1 7/21/2021 1ST REVIEW FROM TOWN OF ROLESVILLE CONSULTANT, WAKE COUNTY OF KALEIGH

KALAS FALLS
PHASE 3
32 ROLESVILLE ROAD
WAKE COINTY NO

DATE: FEB 18, 2021
SHEET TITLE:
PHASE 3
UTILITY
PLAN

DIOMERE LANE PLAN & PROFILE

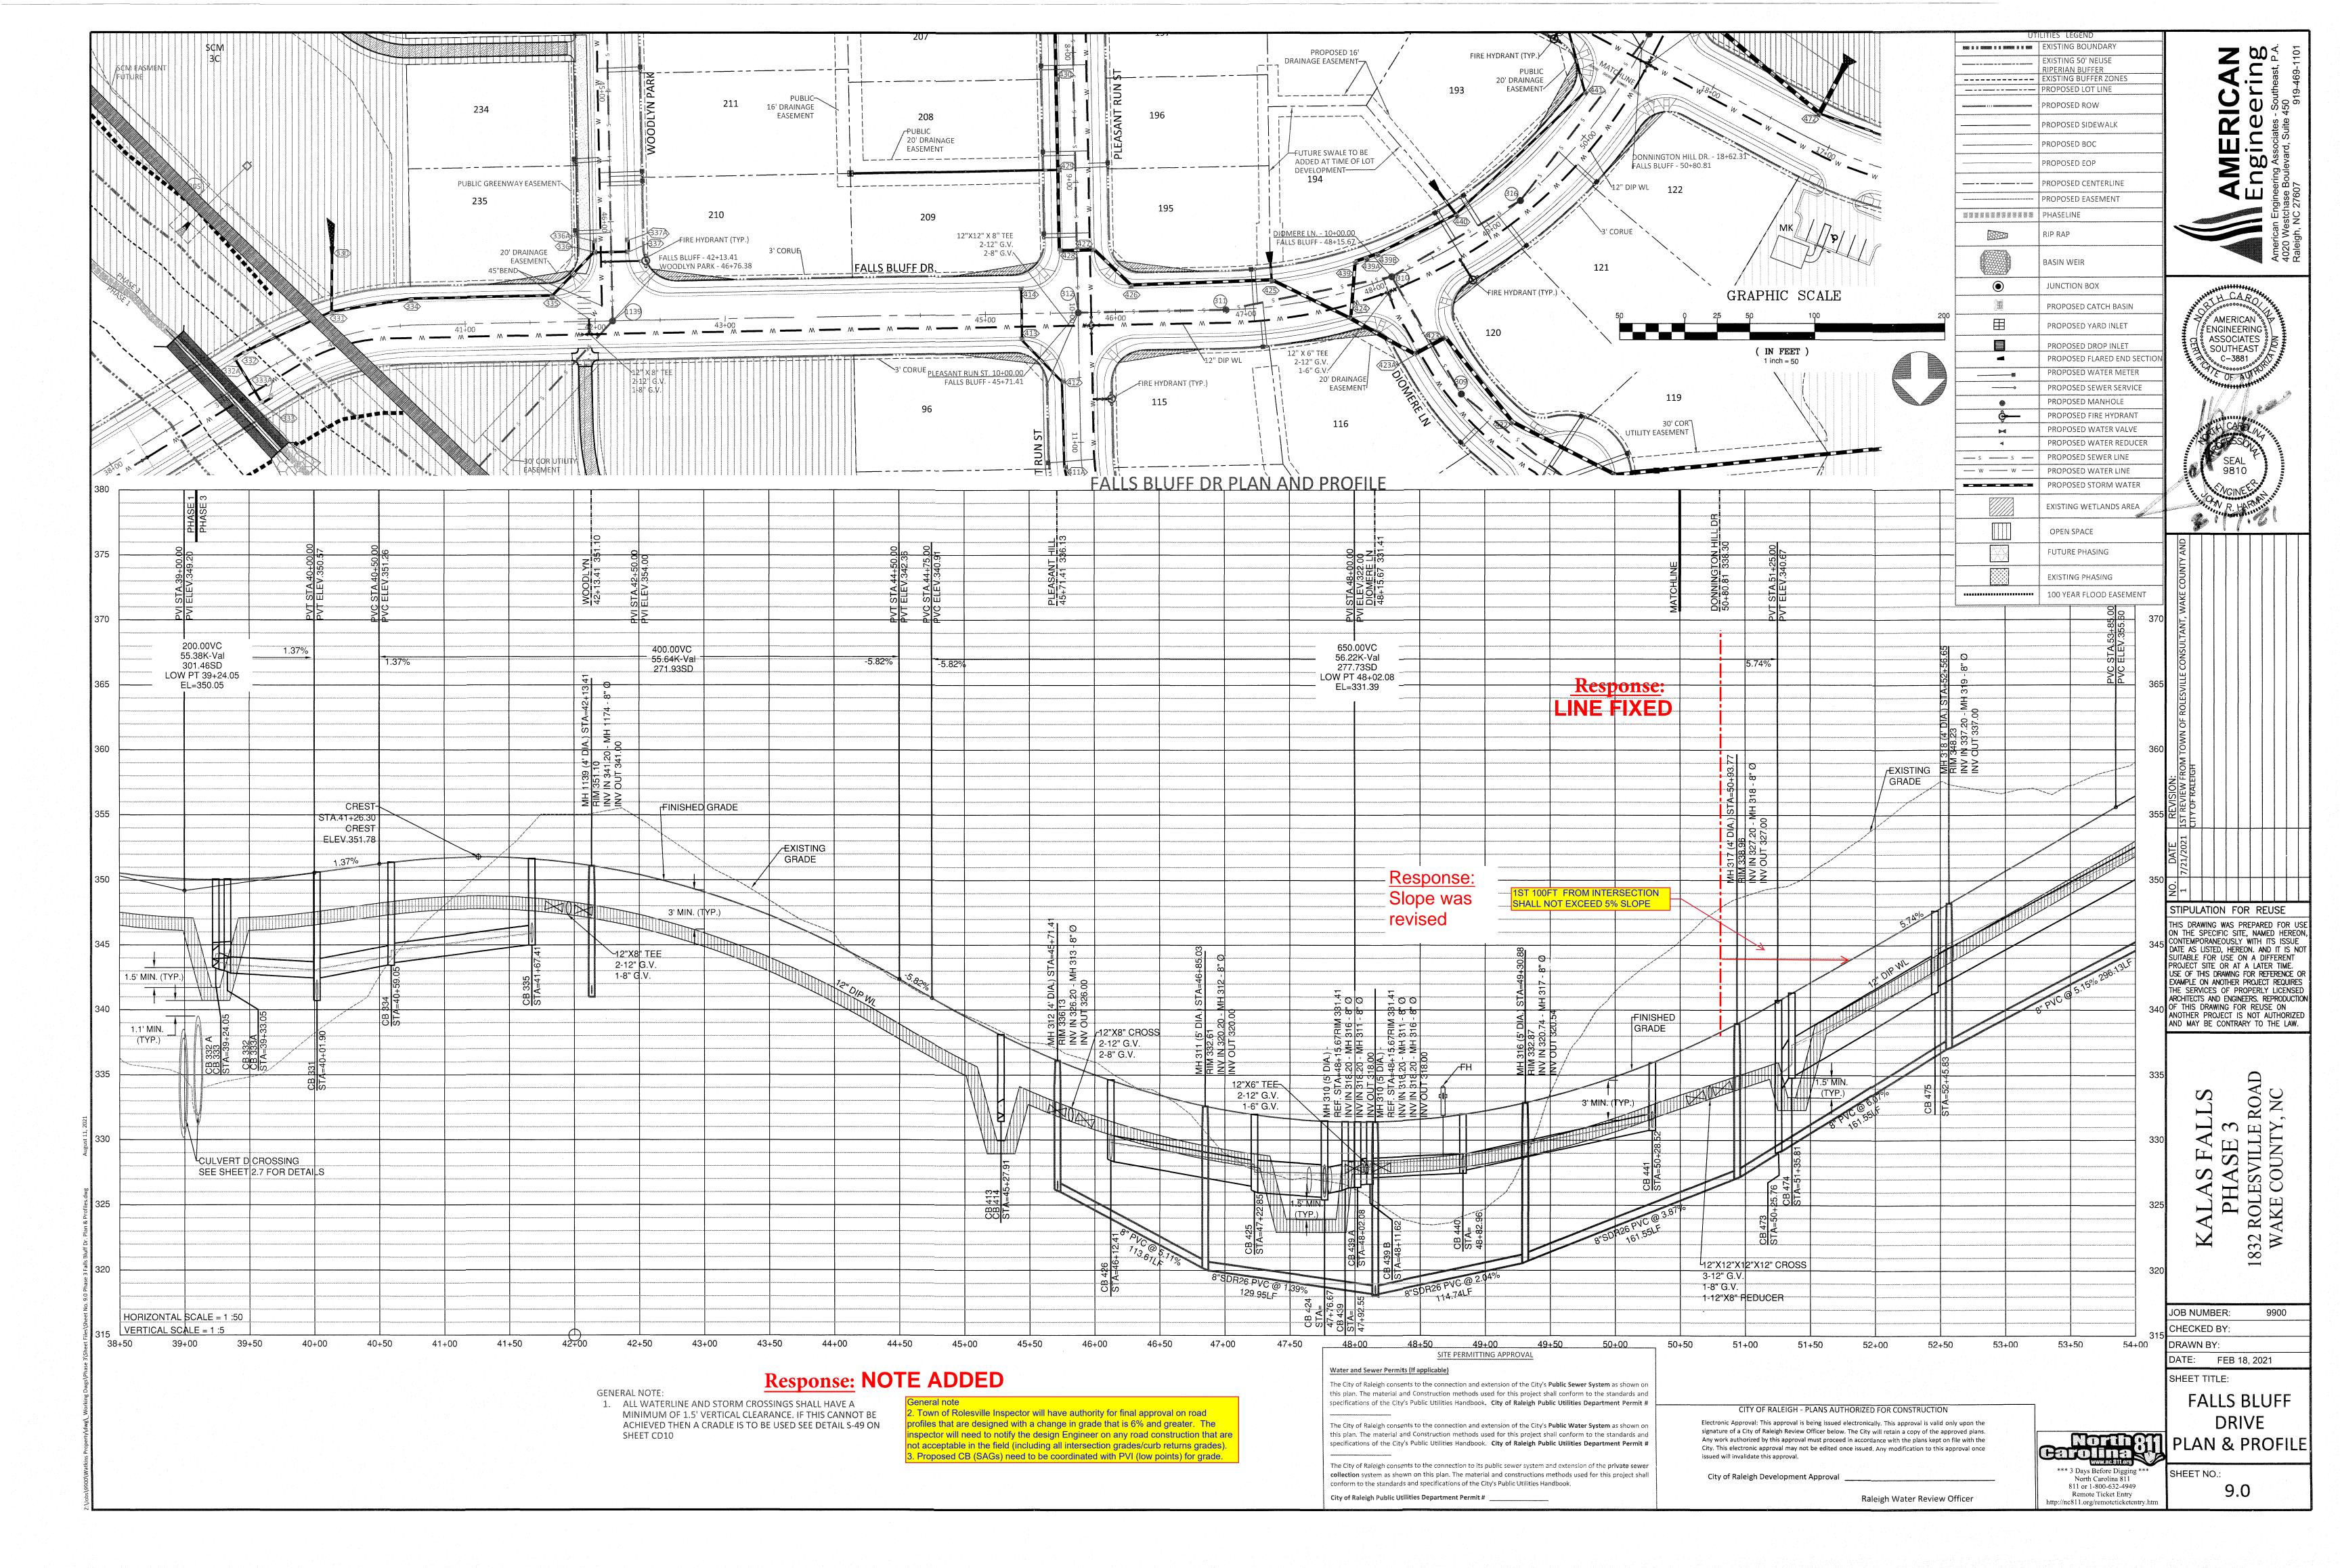
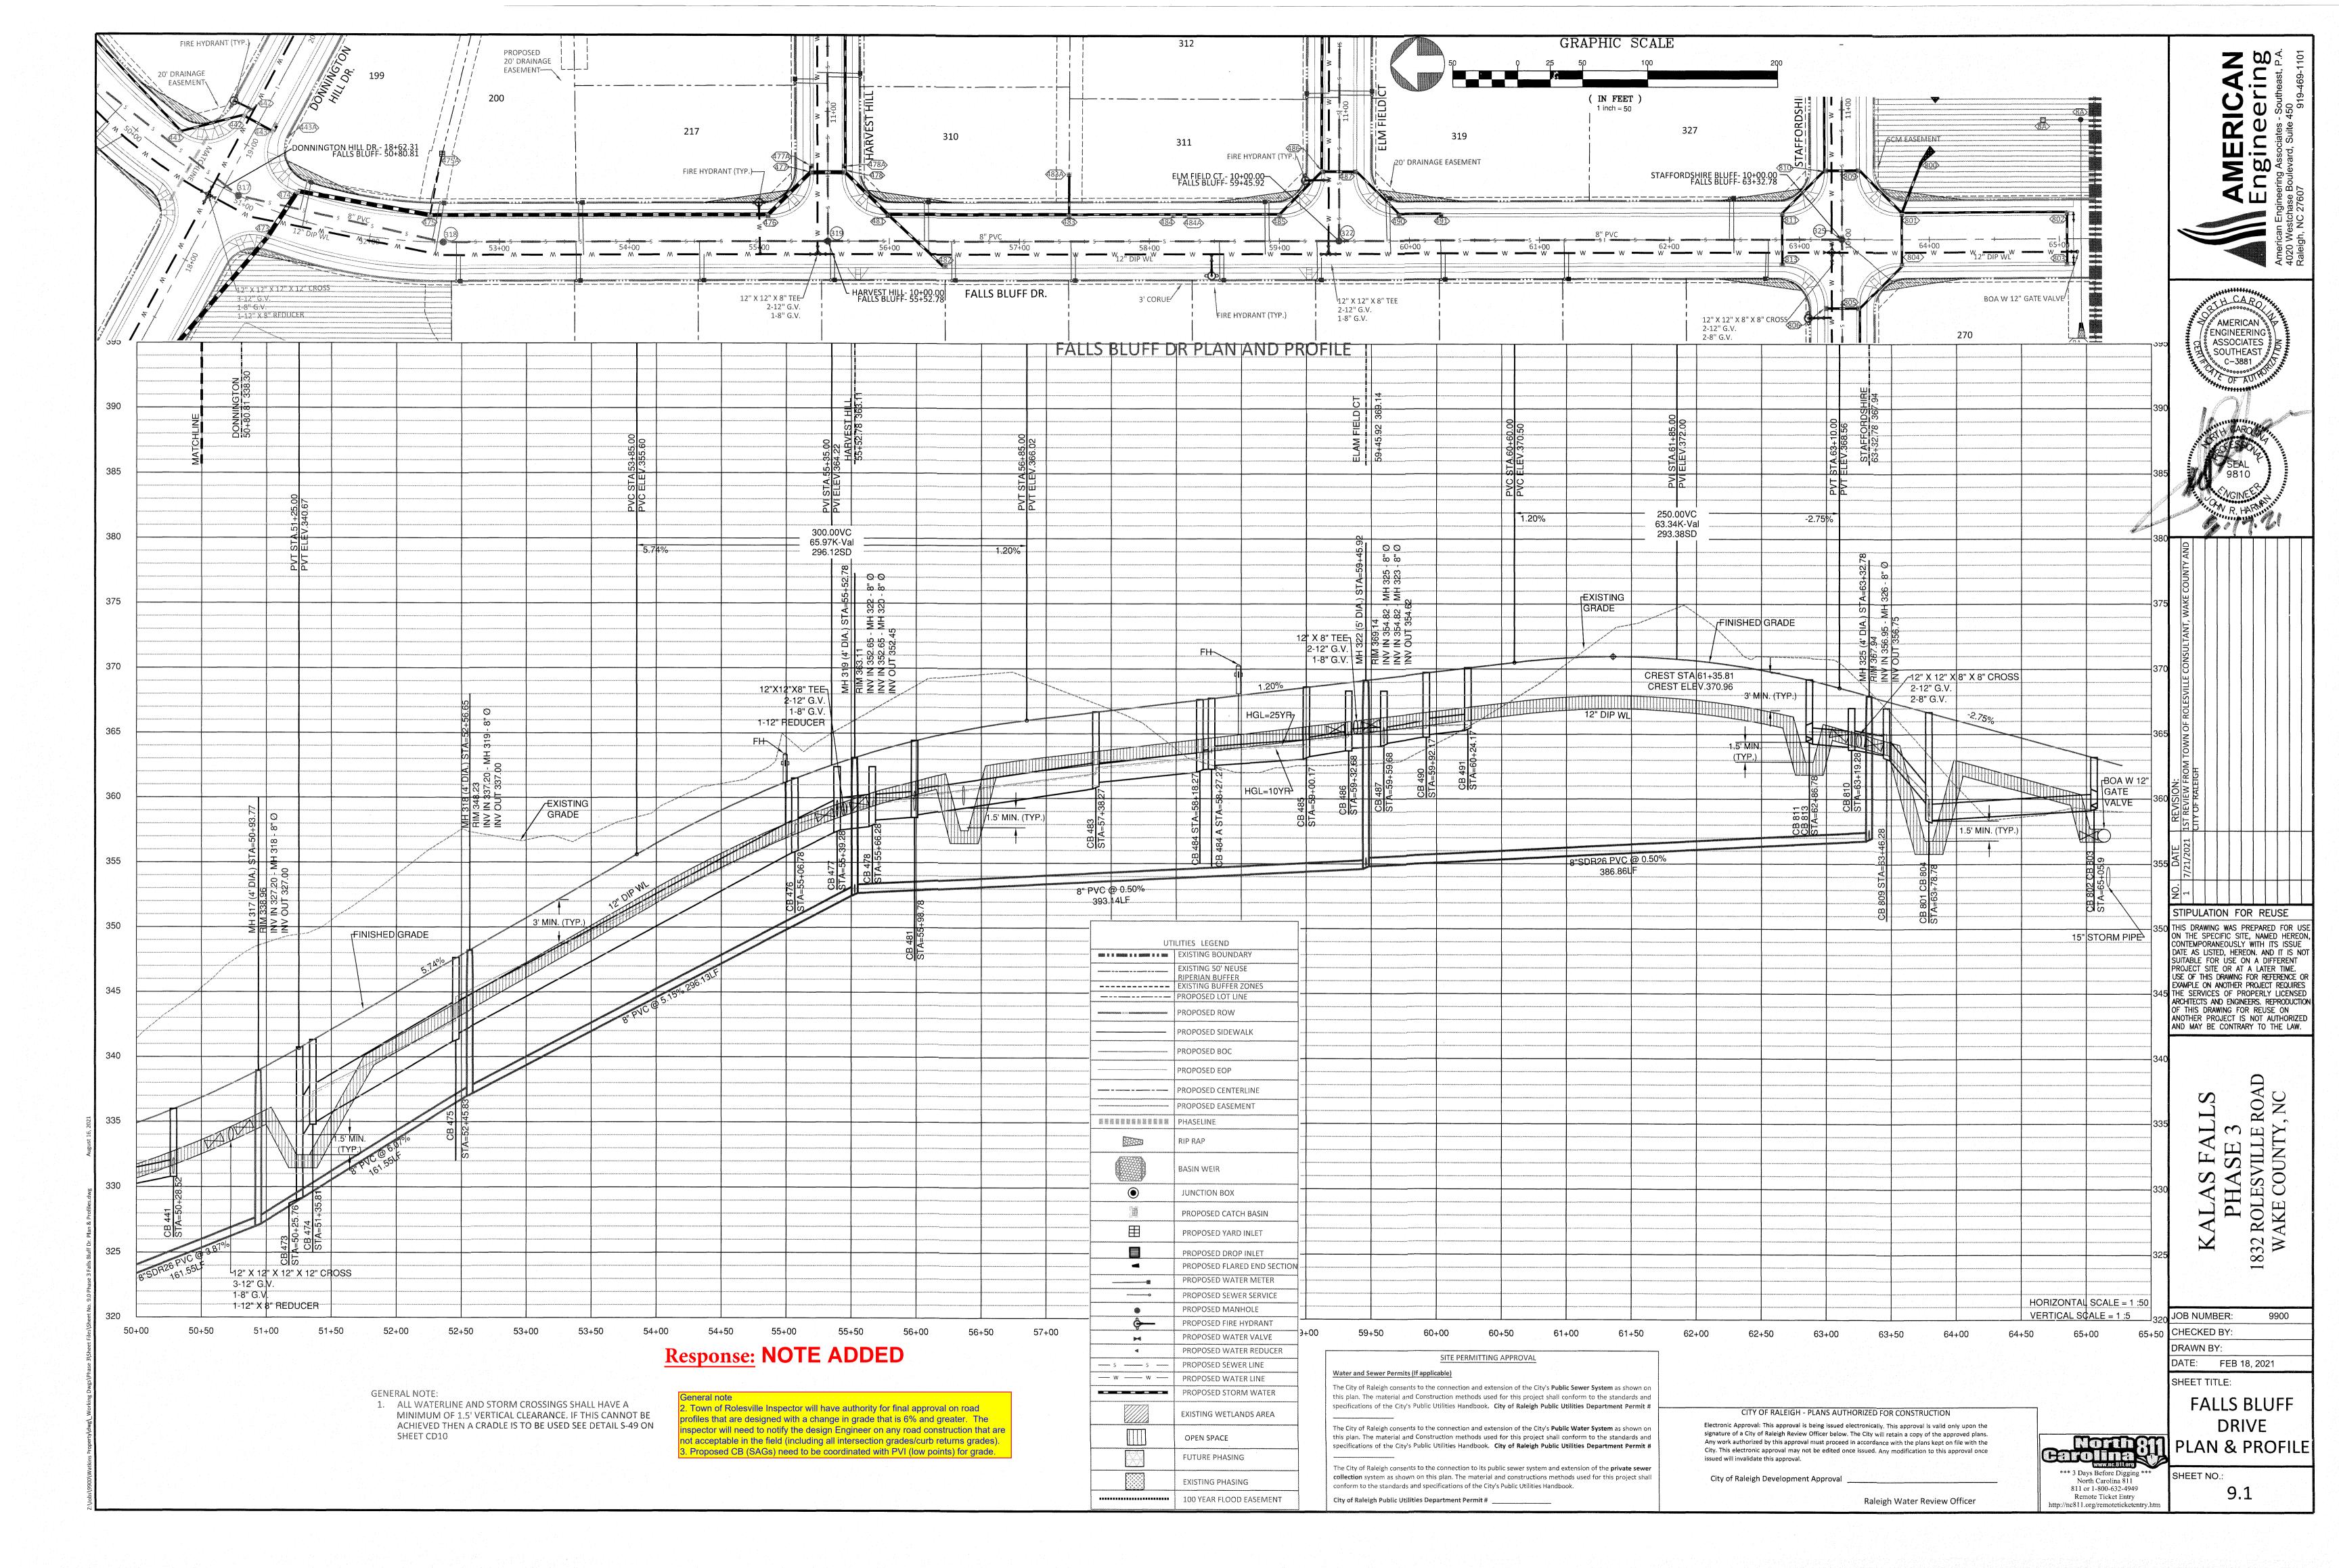
-1ST 100FT FROM INTERSECTION SHALL NOT EXCEED 5% SLOPE Response: This isnt (WHEN ROAD LESS THAN 500', needed per SLOPE MAY BE 150% GREATER) - 7.5% MAX SLOPE FOR 1ST 100 FT conversation the week of 8-26.

> **Response: FIXED**

Response: NOTE HAS BEEN ADDED
